TARMAC KING ROAD
LIMESTONE MINE
LEVY COUNTY, FLORIDA

Second Request for Additional Information Response
File Number 0244771-002

Re: **Request for Additional Information 2**
Tarmac America – Titan King Road Mine
File No. 0244771-002, Levy County

Request for Additional Information Response

PROJECT No. 08112001.001
SHEET 4 of 4

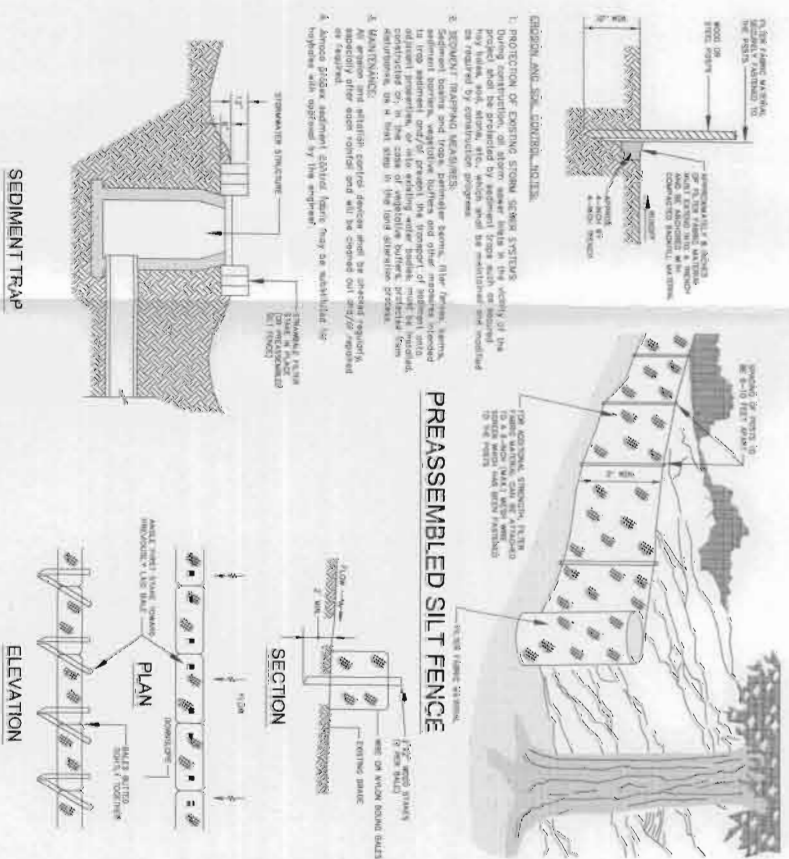
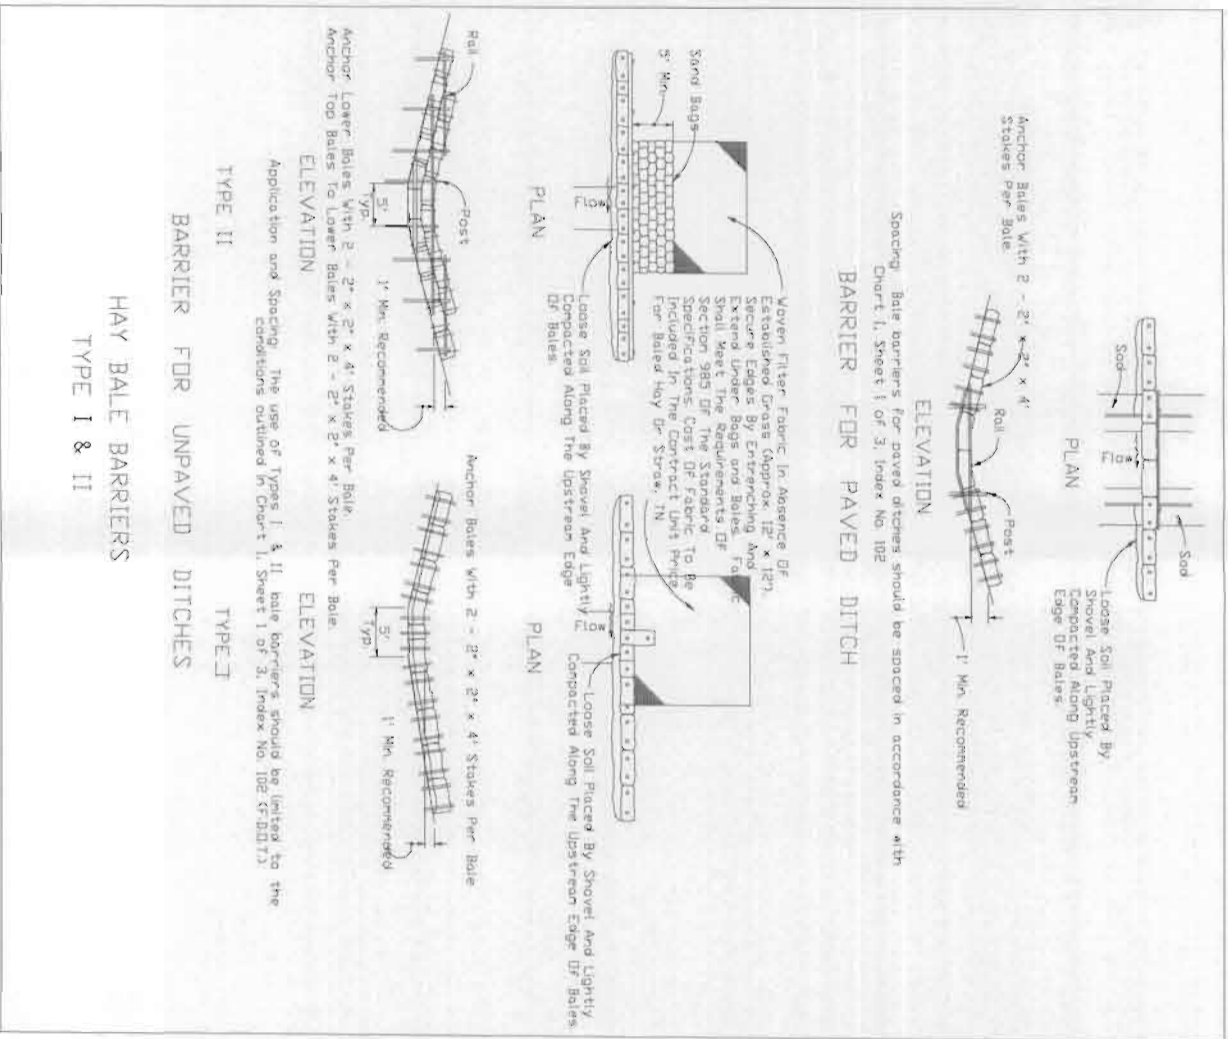
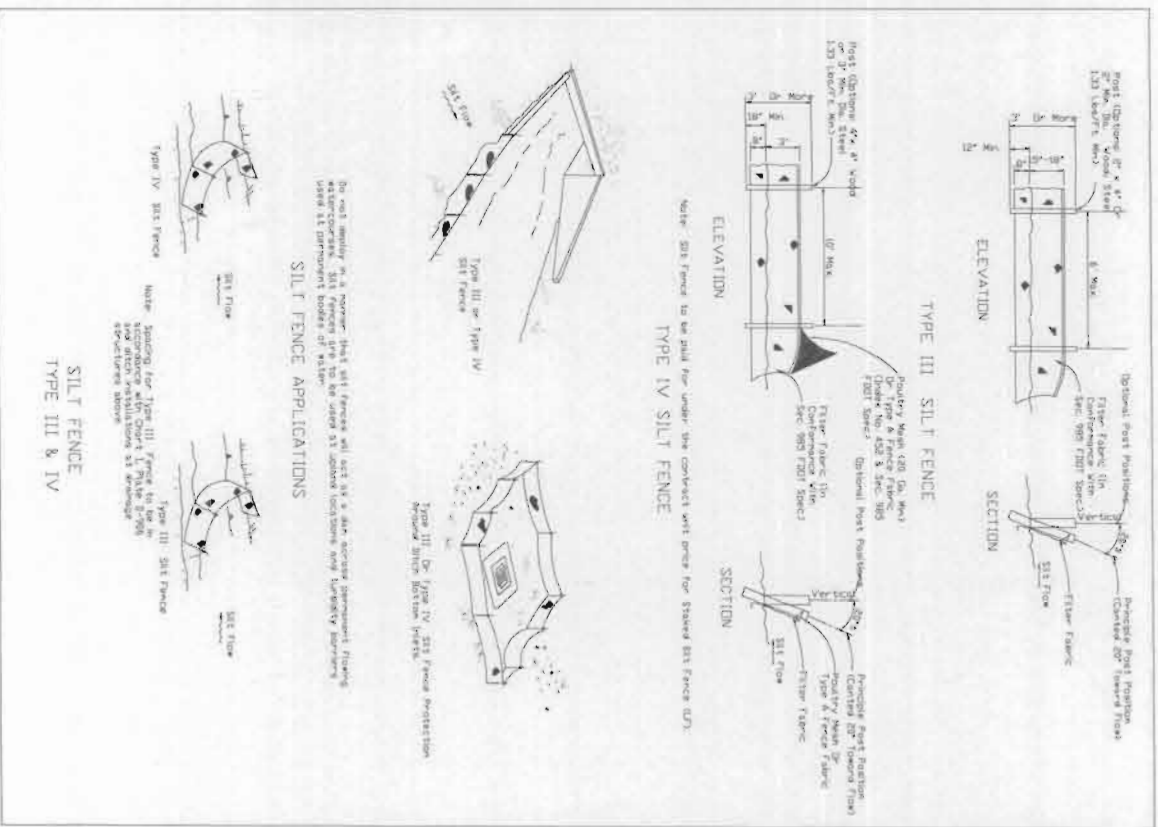
DEP 19. The section H, "Typical Final Mineout Section", sheet D4 of 4 does not meet the reclamation performance standards of Chapter 62C-36, F.A.C.

Response: Please see revised Sheet D4 of Attachment 5, Engineering Drawings.
